February 14, 1992
LD-92-020

Subject: Response to NRC Requests for Additional Information

RESPONSE TO NRC REQUESTS FOR ADDITIONAL INFORMATION
REACTOR SYSTEMS BRANCH

FIGURE 1

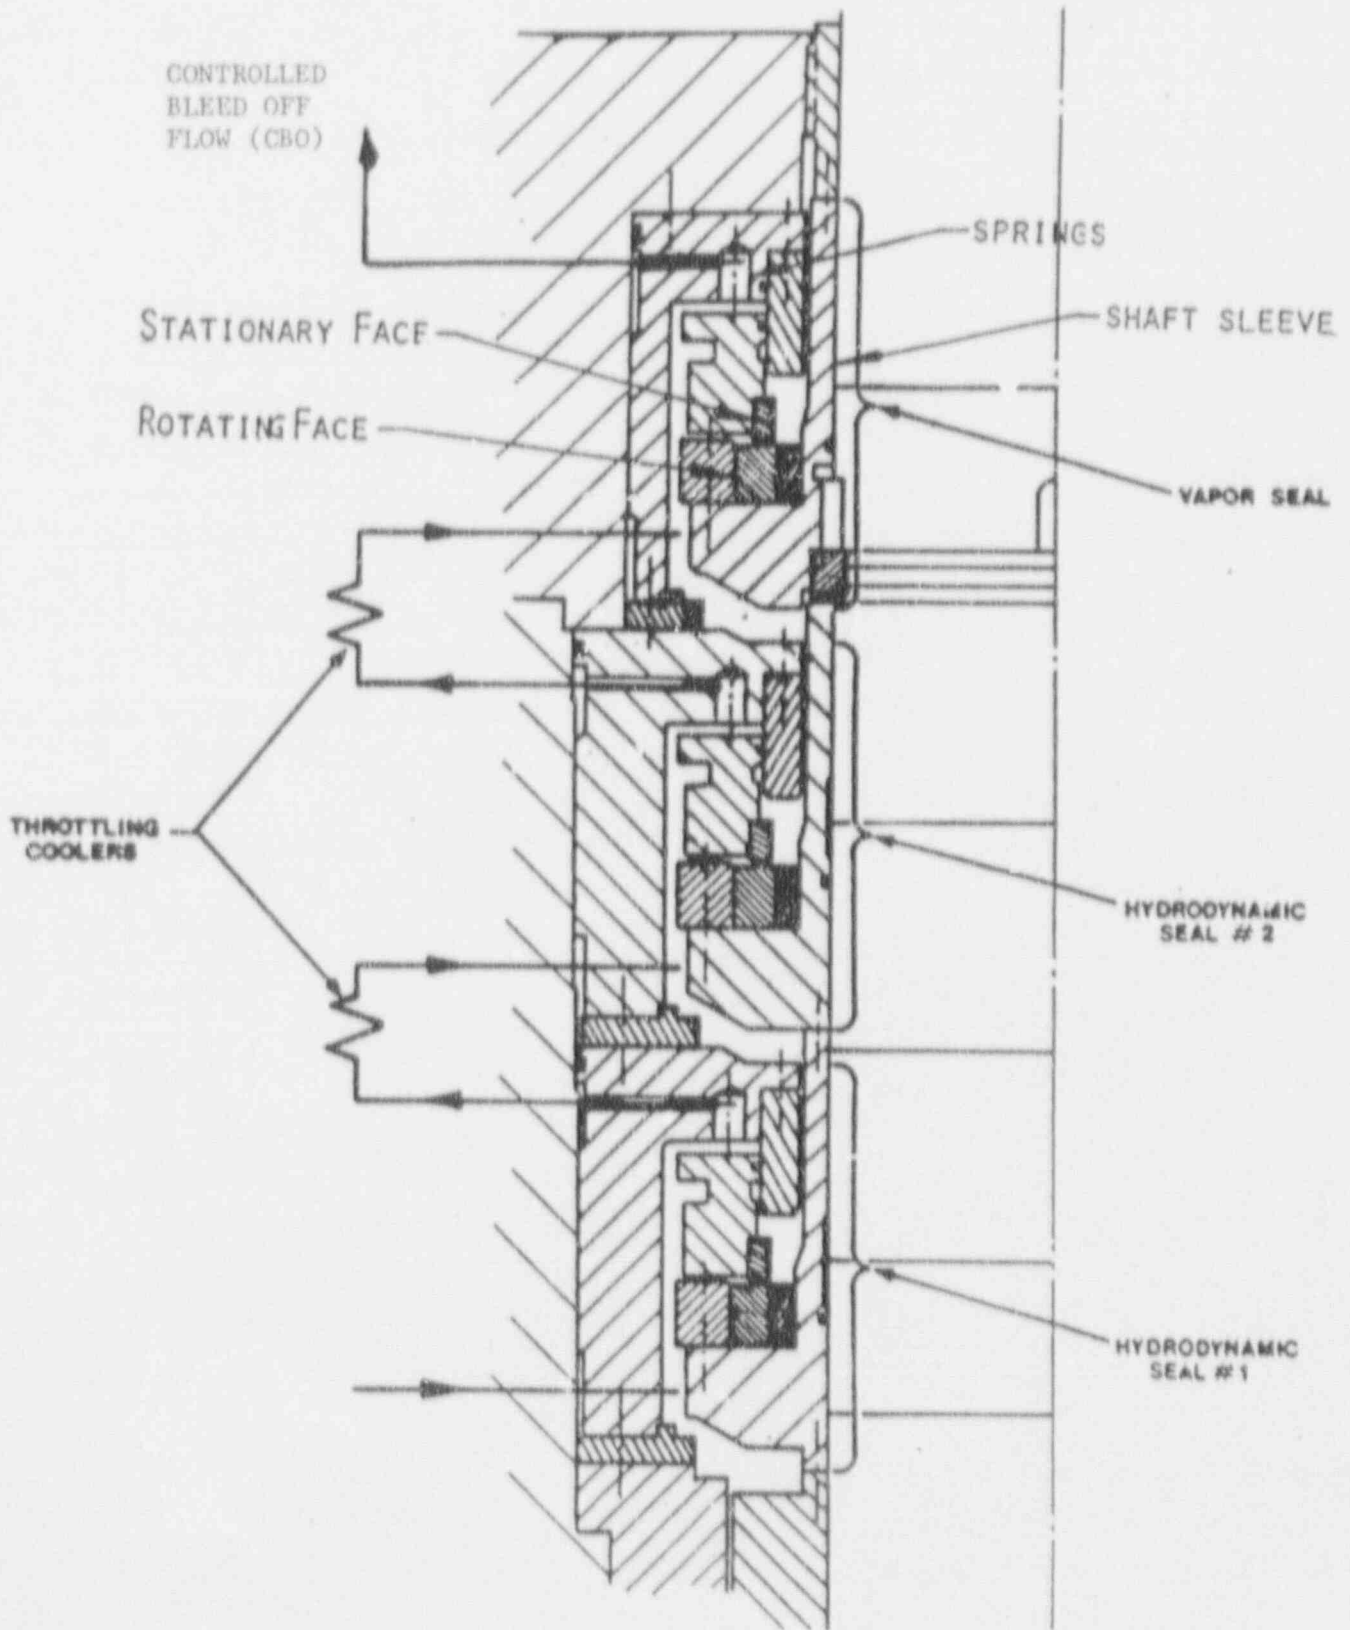
As part of the response to the above RAIs related to RCP seal integrity (GSI-23) and HPSC/TSC tube rupture analysis, provide a color coded simplified P&ID(s) of the CE-KSB RCP shaft seal system to be used in the System 80+ design clearly identifying:

The System 80+ RCP uses a system of three seals, Figure 1, to seal the main shaft. The seals are supplied with filtered, chemically controlled seal injection water by the Chemical Volume Control System (CVCS). Two hydrodynamic seals are mounted in series, with a third stage vapor seal mounted above the two lower stages. Reactor coolant system (RCS) pressure is reduced to volume control tank pressure in stages by the controlled leakage bypass system, which contains throttling devices which are also called throttle seal coolers (TSC). The first two seals provide approximately 84 percent of the system pressure drop (42 percent each). The pressure drop across the third seal is approximately 16 percent. Each of the three seals is capable of operating at full system pressure.
